SERVICE BULLETIN No. 6647-32-9

LANDING GEAR - EXTENSION AND RETRACTION - CONTROL AND INTERFACE

POWER SUPPLY/FILTER ASSEMBLY - PRECAUTIONARY REPLACEMENT OF GROMMETS

Figure 1 Power Supply/Filter Assembly - Grommet Positions

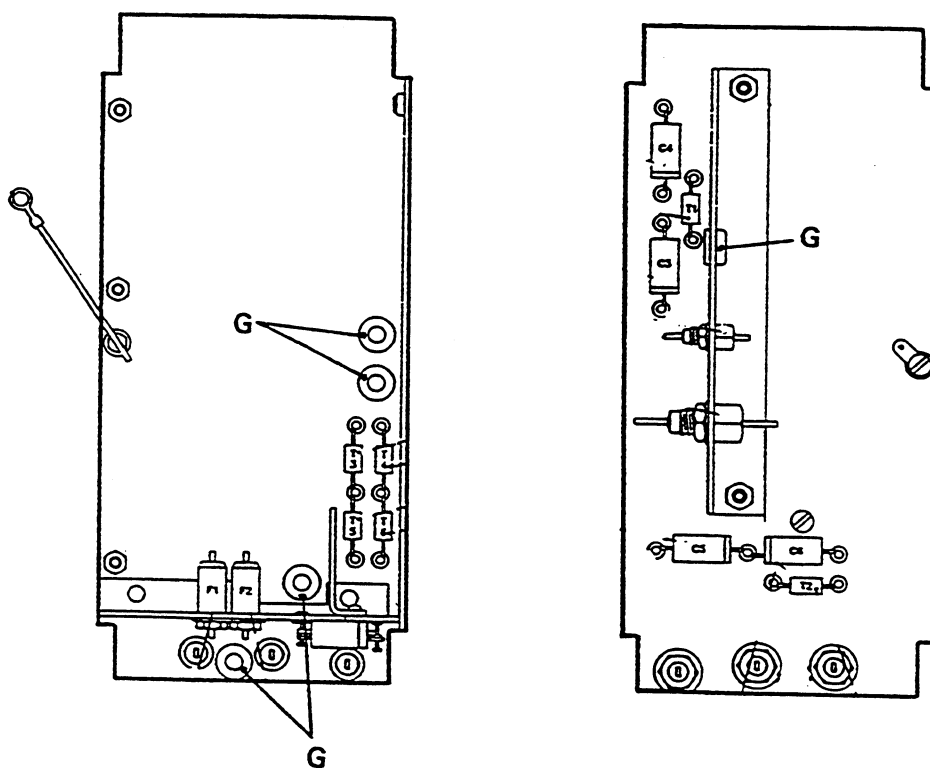
Five insulating grommets used in the power supply/filter assembly, Pt. No. 001LG010380 have been found to exhibit a tendency to hardening and subsequent cracking after extended service.

- (1) Remove three M3 screws (150), two M3 nuts (155), two lock washers (160) and two plain washers (165) which secure the power supply module (145) to the power supply/filter assembly (135).
- (2) Refer to Fig. 1 of this Service Bulletin and identify the five grommets (letter G). At this stage you should be able to gain access to all five grommets without further disassembly.

This Service Bulletin introduces the precautionary replacement of the suspect grommets by items manufactured from a different compound. Accomplishment of this Service Bulletin constitutes a complete fix.

- (1) Identify the wires which you must unsolder in order to fit the new grommets. Tag these wires and make a note of the routing of each wire.
- (2) Taking each grommet in turn, unsolder the relevant wires, remove and discard the original grommet.
- (3) Fit the new grommet and resolder the wires. Renew any cable ties which you have had to cut.
- (4) Repeat this procedure until all five grommets have been replaced.
